# **Responses to ExQ2**

**Application by Highways England for A63 Castle Street Improvement Hull**

**TR010016**

**Image 2 – Extract from approved NMA plan showing steps reorientated.**

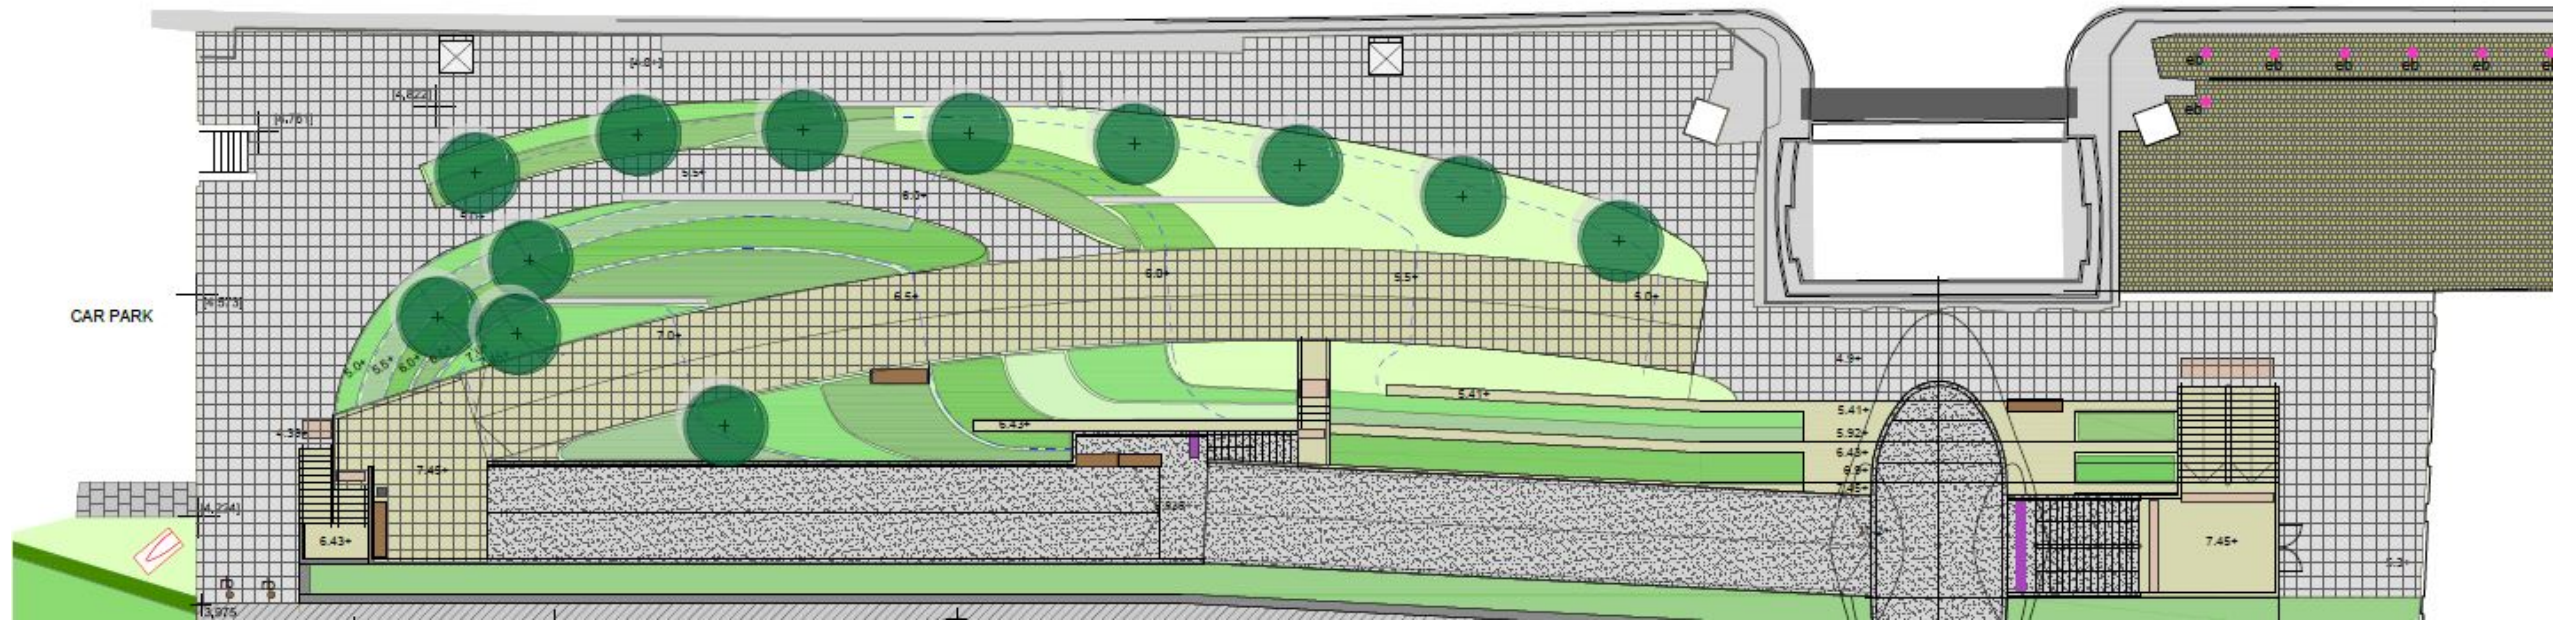
ExQ2	Question to:	Question:	HCC response:
			<p>flexibility had been factored in to accommodate NMU routing approaching and around the bridge, nor the routing strategy within the emerging main scheme, discussions at the time and subsequently have revealed that the amendments were sought in order to accommodate the number of carriageway lanes required for the main scheme, along with sufficient width along the adjacent carriageway for shared cycle and pedestrian use. The north-western approach to the bridge is depicted with an existing footpath terminating in the region of the base of the steps as re-orientated 'to be retained' (see appendix B image 2).</p> <p>On submission of the improvement scheme application, and submission perusal of the application plans and supporting documents, it became apparent that the NMU routing as described would require users to make an acute right angled turn from the NMU route shown adjacent to the A63 carriageway in order to access the steps or indeed the secondary ramp beyond. This is in part due to the fact that the parcel of land to the south of the Princes Quay shopping centre car park, namely land parcel 5/2c, is identified to be occupied or used in connection with the scheme for a temporary period of time only. This outcome is of concern to the Council in terms of legibility, given the significance that this route is set to take on as a key connection across the A63 between Paragon transport interchange, past the Bonus Arena to the bridge and the Marina, Fruit Market, and Victoria Dock Village beyond. The diminished user experience and weakened legibility would be compounded by the impact of the resultant high blank corner wall which would present on approach due to the re-orientation of the steps. Furthermore, the acuteness of this angle and the impact of the high wall on legibility raises the potential for travellers, particularly the partially those with visual impairment, cognitive impairment, or cyclists and mobility scooter users</p>

ExQ2	Question to:	Question:	HCC response:
			<p>travelling at any speed to miss the turn and consequently direct and convenient access to the bridge (see Appendix B images 3 &amp; 4).</p> <p>At this juncture, the Council can report that constructive discussions held with the undertaker have resulted in the tabling of an amended draft design by the later, which the Council, subject to confirmation of final design details, can support, and which address, in large measure, the concerns described above, by returning the steps, albeit in a different position and arrangement, to their original orientation.</p> <p>In developing this revision, the Applicant identified a pinch point between the foot of the re-orientated steps as described, and the corner of the retaining wall to land parcel 5/2c. The Council owns the freehold of the land in question, and an agreement between the Council and the relevant leaseholder over the control of that land is imminent, which would enable the Council to facilitate the provision of a more generous approach route and remove the identified pinch-point.</p> <p>Subject to the completion of the agreement referred to above, understood to be imminent, a further non-material amendment submission to the local planning authority would be required in order to enable the works on site to continue in advance of the SoS's determination of the DCO application. HCC understand that the Applicant is about to submit this NMA application in the coming days, and HCC will forward relevant details to the ExA, both upon receipt and following determination.</p> <p>Similarly, the Council would recommend that the relevant plans and drawings which depict the bridge steps and the NMU route</p>
